**METROPOLITAN GOVERNMENT OF NASHVILLE AND DAVIDSON COUNTY**

**STAFF RECOMMENDATION**  
**417 Park Circle**  
**March 19, 2014**

**Application:** New construction - infill  
**District:** Richland-West End Addition Neighborhood Conservation Zoning Overlay  
**Council District:** 24  
**Map and Parcel Number:** 10405043500  
**Applicant:** Daryl Adler, Acklen Property Group, LLC  
**Project Lead:** Sean Alexander, sean.alexander@nashville.gov

417 PARCK CIRCLE TOWNHOMES 417 A & B PARK CIRCLE LOT 20 HARDISON & YOUNG SUBDIVISION			
SCALE 1" = 40'	DRAWN BY T.E.W.	APPROVED T.E.W.	DATE 1/27/14
24TH COUNCILMANIC DISTRICT			
DAVIDSON COUNTY TENNESSEE		DRAWING NO. DAPARCK

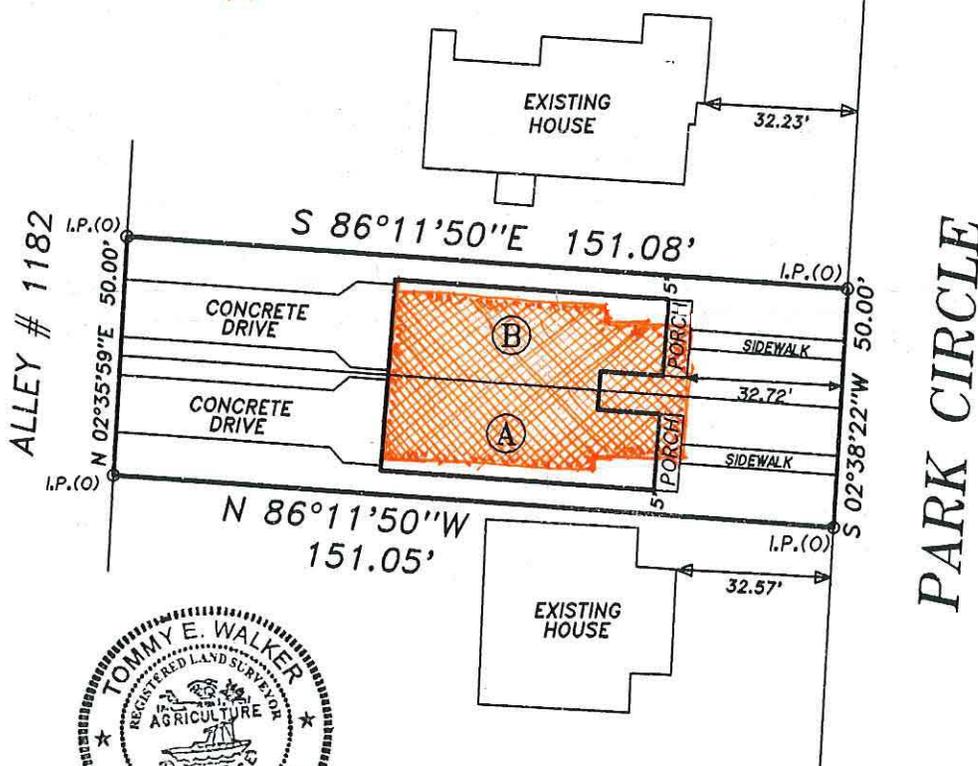
(Note – An updated site plan showing revisions made to the plan is needed before permitting)

= Current proposal footprint.  
 Applicant to verify + resubmit revised siteplan.

1  
**FRONT ELEVATION**

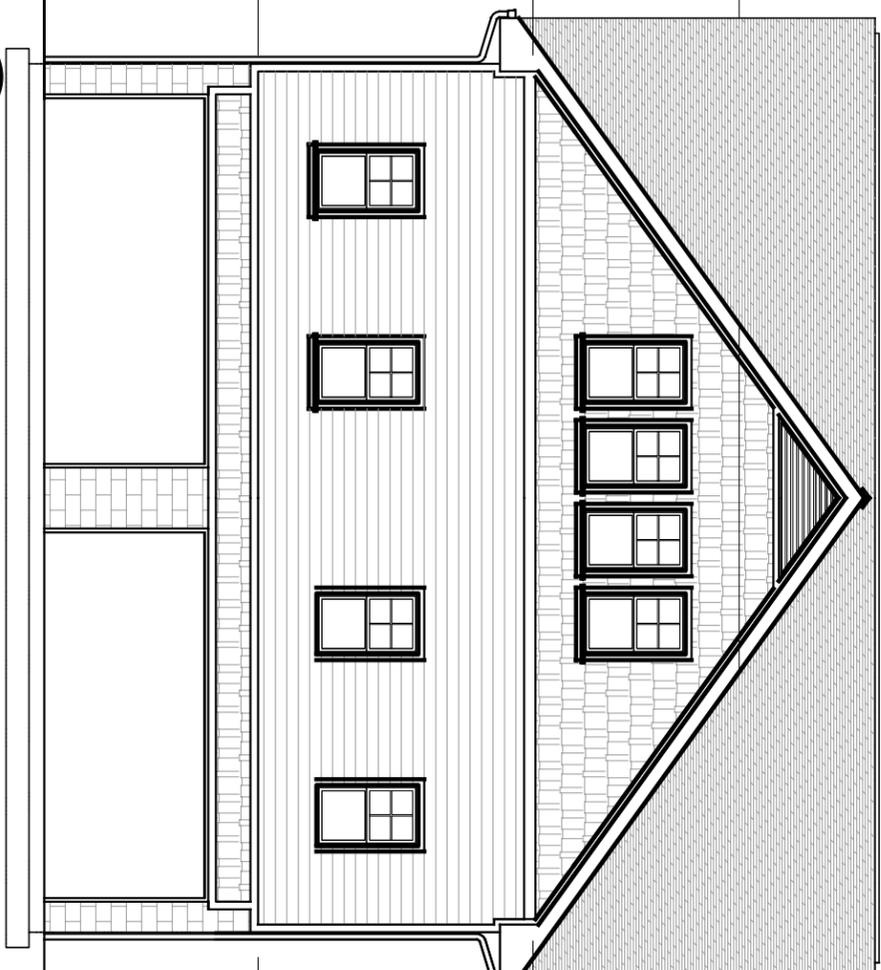
The roof of the porch as depicted in the elevations would be a steeply pitched shed roof with no overhang. Staff finds that this porch roof is not compatible with historic houses, and would need to be revised. With a porch roof with a lower pitch and overhangs as approved by Staff, staff finds that the proposal would meet guideline II.B.1.e.

- Staff shall approve the color of the roof;
- The porch roof shall be revised to be more compatible with surrounding houses, as approved by Staff;
- Staff shall approve the material of the porch floor, and of the windows and doors;
- Staff shall approve the location of the external HVAC unit; and,
- The plans and elevations shall be updated with all materials and dimensions labeled.
